# Access Compliance Report

## Public Rights-of-Way

Intersection ID: 26688	Main Street: STIRRUP_RIDGE_LN	Cross Street: WINTHROP_RIDGE_RD	Location: NW
ADA ID: 5836E5F52CAD	Ramp Type: Perp	Initial Pass/Fail: Fail	Overall Compliance: No
		Severity Score: 10

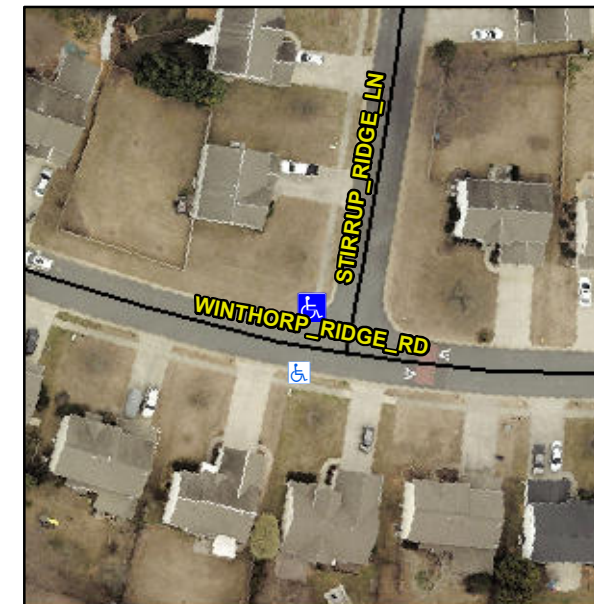
**Not Found, R304.5.1, R304.5.3**

Compliance	Description	Data	Compliance	Description	Data
N/A	Ramp Length (in)	47.5	Yes	Ramp Slope (%)	8.1
No	Ramp Width (in)	41.0	No	Ramp XSlope (%)	3.5
N/A	Flare Type LT	N/A	N/A	Flare Type RT	N/A
N/A	Flare Slope LT (%)	N/A	N/A	Flare Slope RT (%)	N/A
N/A	Flare Traversable LT?	N/A	N/A	Flare Traversable RT?	N/A
N/A	Landing Length (in)	N/A	N/A	DWS Provided?	N/A
N/A	Landing Width (in)	N/A	N/A	DWS Contrast?	N/A
N/A	Landing Slope (%)	N/A	N/A	DWS Length (in)	N/A
N/A	Landing X Slope (%)	N/A	N/A	DWS Full Width?	N/A
N/A	Landing Curb? (Y/N)	N/A	N/A	DWS Offset (in)	N/A
N/A	Shared Landing?	N/A			
N/A	Gutter Ponding?	N/A	N/A	Gutter Slope (%)	N/A
N/A	Gutter Lip Ht (in)	N/A	N/A	Gutter X Slope (%)	N/A
N/A	Painted X Walk1?	No	N/A	Painted X Walk2?	N/A
	X Walk 1 Direction	To S		X Walk 2 Direction	N/A
N/A	X Walk 1 Width (in)	N/A	N/A	X Walk 2 Width (in)	N/A
	X Walk 1 Slope (%)	2.8		X Walk 2 Slope (%)	N/A
	X Walk 1 X Slope (%)	0.1		X Walk 2 X Slope (%)	N/A

**Remove & Replace Entire Ramp.**
